PROJECT TITLE: New Cooling Tower & Enclosure

PROJECT NO.: BI-2B-272

**COOLING TOWER REPLACEMENT
61 WOODLAND STREET
HARTFORD, CONNECTICUT
PROJECT: BI-2B-272**

ADDENDUM NUMBER 2 (Two)

DRAWING TITLE: PARTIAL HIGH ROOF LEVEL PLAN: SUPPLEMENTAL BID 01	DWG. NO.:	SKA-01	
	DATE:		
PROJECT: COOLING TOWER REPLACEMENT 61 WOOLDAND STREET BI-2B-272	RE: 2/A6.2.1	SCALE:	1/4"=1'-0"
		JOB NO.:	CT.58.AR
		REVISED:

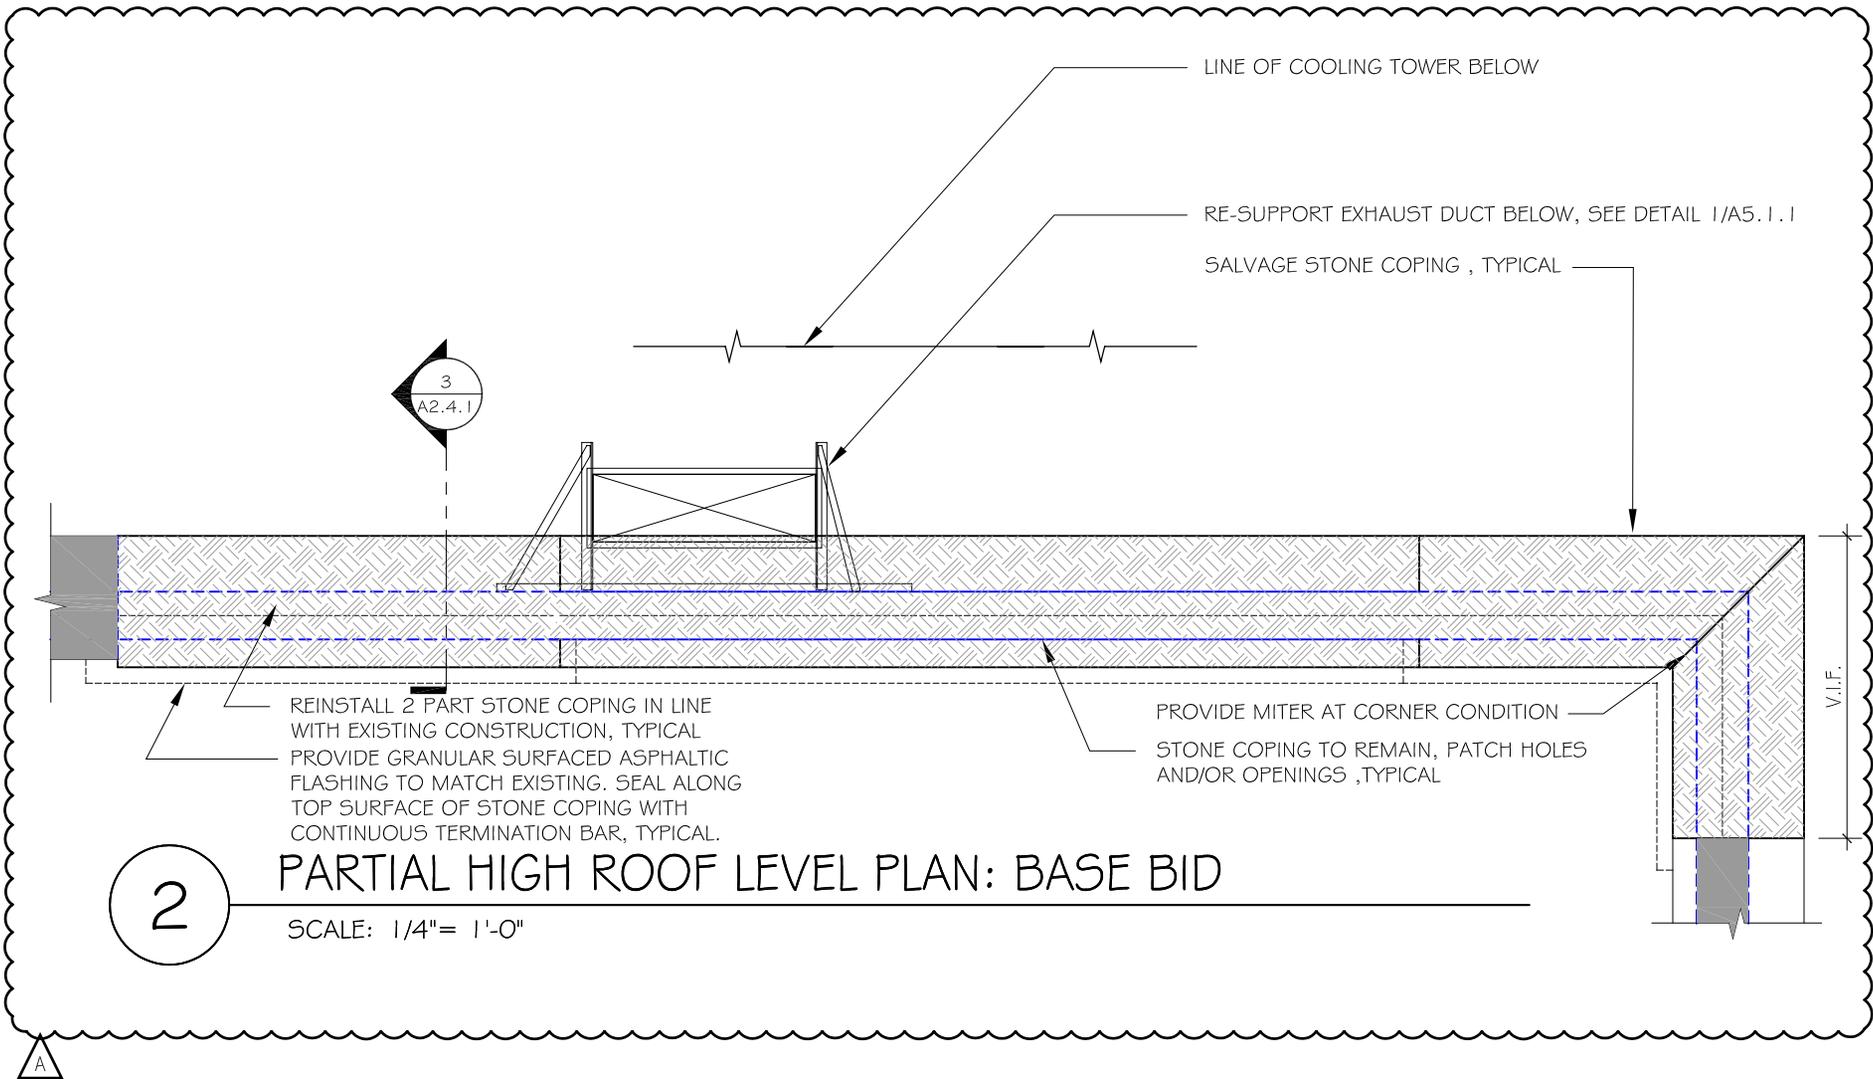
Drawing A2.6.2: REPLACE Detail 2/A2.6.2 with Sketch SKA-01

DRAWING TITLE:	WEST ELEVATION (SUPPLEMENTAL BID 01)	DWG. NO:	SKA-04	DATE:	10/27/2009
		PROJECT:	COOLING TOWER REPLACE'T 61 WOODLAND STREET HARTFORD, CT 06105	SCALE:	1/4" = 1'-0"
RE: 1/A6.3.2				JOB NO:	BI-2B-272 / CT.58.AR
				REVISED:

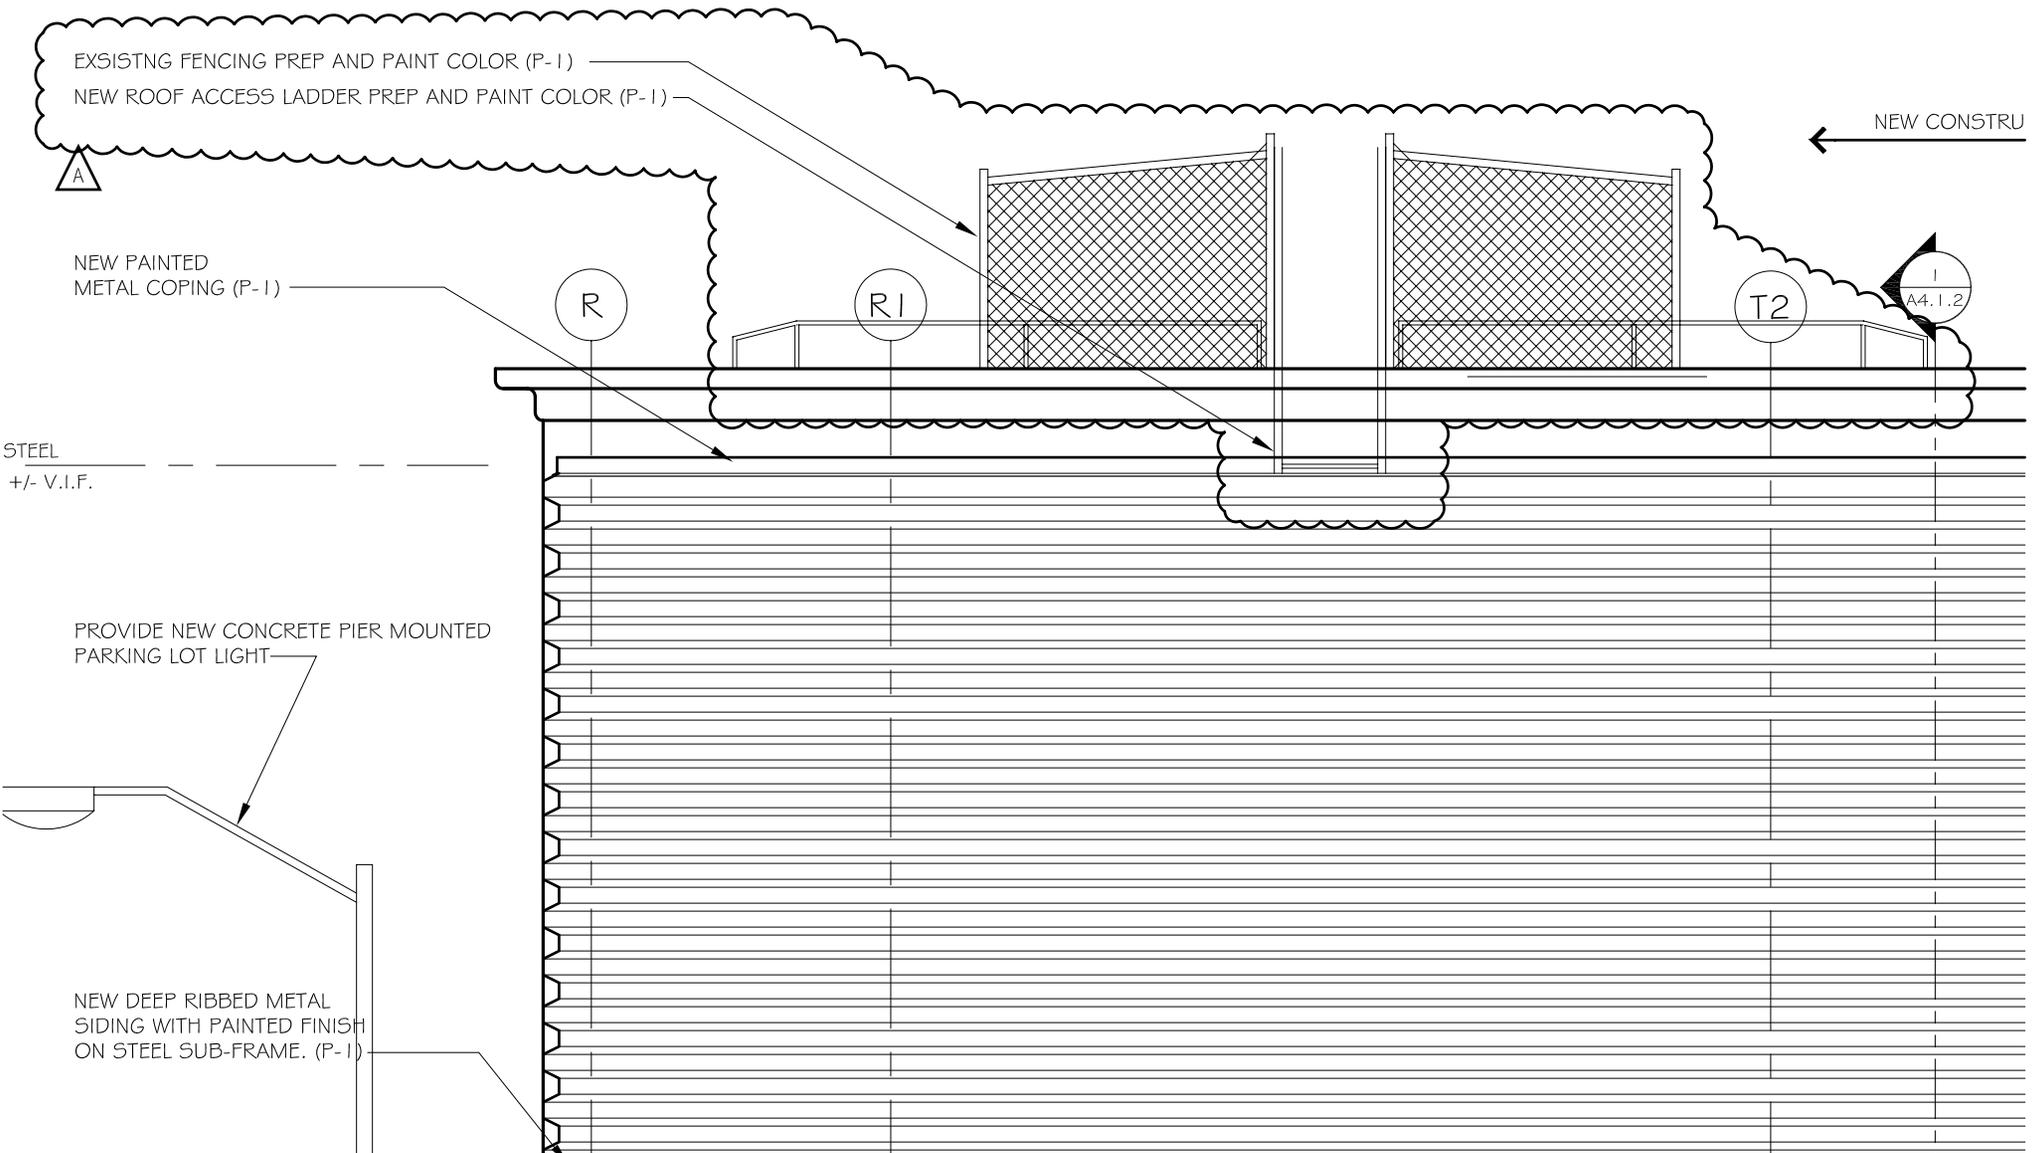
Drawing A6.3.2: MODIFY West Elevation with Sketch SKA-04

DRAWING TITLE: PARTIAL HIGH ROOF LEVEL PLAN: SUPPLEMENTAL BID 01	DWG. NO.:	SKA-01	DATE:	08/24/09
	RE: 2/A6.2.1		SCALE:	1/4"=1'-0"
PROJECT: COOLING TOWER REPLACEMENT 61 WOOLLAND STREET BI-2B-272	TectonArchitects inc		JOB NO.:	CT:58.AR
		REVISED:

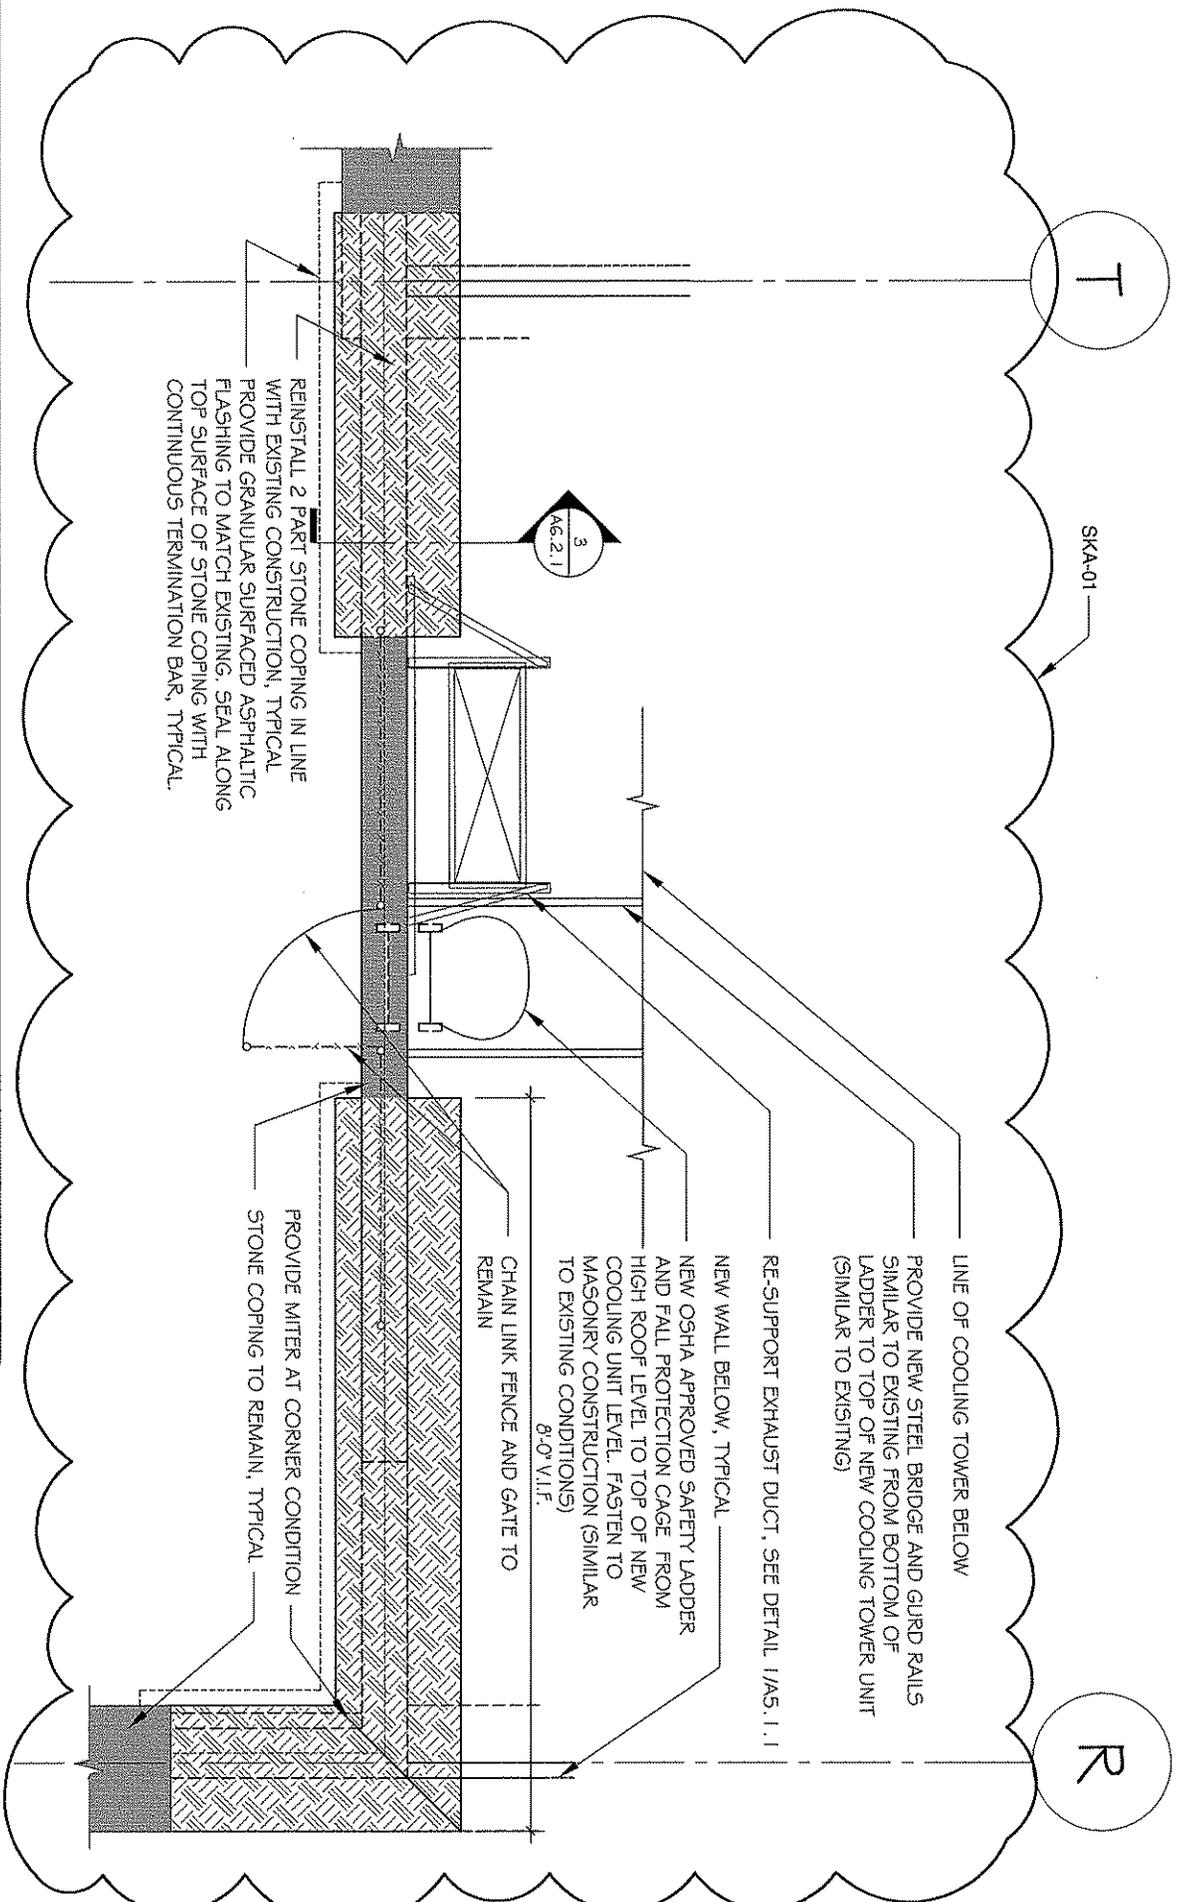
West Elevation 1/A3.1.2 and roof level demo plan 2/A2.1.2 show the chain link fence, railings and ladder being removed. Partial high roof plan 2/A2.4.1 shows the fence and ladder in place and partial stone coping reinstallation. West Elevation 1/A3.2.2 shows salvaged stone coping installed across the entire high roof parapet with no fence or ladder. Partial high roof plan 2/A6.2.1, for Supplemental Bid #1, also shows the existing fence and ladder (with new safety cage) to remain and partial stone coping reinstallation. Please clarify the high roof parapet work for both Base Bid and Supplemental Bid #1.

Substitute detail SKA-001 in lieu of 2/A6.2.1 for clarification of parapet replacement scope.

REINSTALL 2 PART STONE COPING IN LINE WITH EXISTING CONSTRUCTION, TYPICAL. PROVIDE GRANULAR SURFACED ASPHALTIC FLASHING TO MATCH EXISTING. SEAL ALONG TOP SURFACE OF STONE COPING WITH CONTINUOUS TERMINATION BAR, TYPICAL.

LINE OF COOLING TOWER BELOW
 PROVIDE NEW STEEL BRIDGE AND GIRD RAILS SIMILAR TO EXISTING FROM BOTTOM OF LADDER TO TOP OF NEW COOLING TOWER UNIT (SIMILAR TO EXISTING)

NEW WALL BELOW, TYPICAL
 NEW OSHA APPROVED SAFETY LADDER AND FALL PROTECTION CAGE FROM HIGH ROOF LEVEL TO TOP OF NEW COOLING UNIT LEVEL. FASTEN TO MASONRY CONSTRUCTION (SIMILAR TO EXISTING CONDITIONS)
 8'-0" V.L.F.

CHAIN LINK FENCE AND GATE TO REMAIN

PROVIDE MITER AT CORNER CONDITION
 STONE COPING TO REMAIN, TYPICAL
